July 7, 2005

Missoula County has completed its review of the Draft Restoration Plan for the Clark Fork River and Blackfoot River near Milltown Dam. Written comments are enclosed with this letter, prepared by Mr. Dennis Gathard of G & G Associates and Peter Nielsen of Missoula County. Thank you for providing us with a copy of the draft report and the opportunity to submit comments.

Draft Restoration Plan for Restraining the Clark Fork River and Blackfoot River following the Removal of Milltown Dam

THE STATE OF MONTANA’S RESPONSES TO MISSOULA COUNTY COMMENTS ON THE *DRAFT RESTORATION PLAN FOR THE CLARK FORK RIVER AND BLACKFOOT RIVER NEAR MILLTOWN DAM* (April 2005)

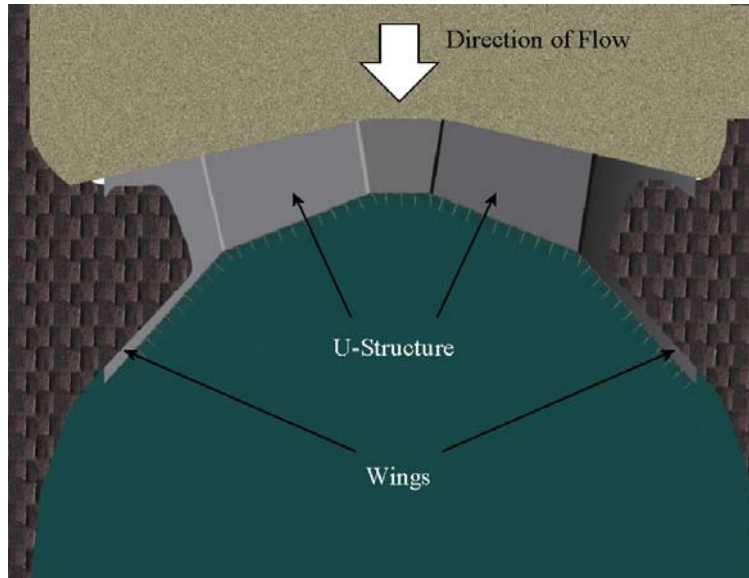
- The proposed profile at the downstream end of CFR3 is similar to the current thalweg elevation (approximately 3246 now versus approximately 3250 proposed). Treatment of CFR3 includes increasing sinuosity and removing mature vegetation. This would appear to create less stability rather more stability since, as discussed, mature vegetation provides a more stable river plan form than recent vegetation.
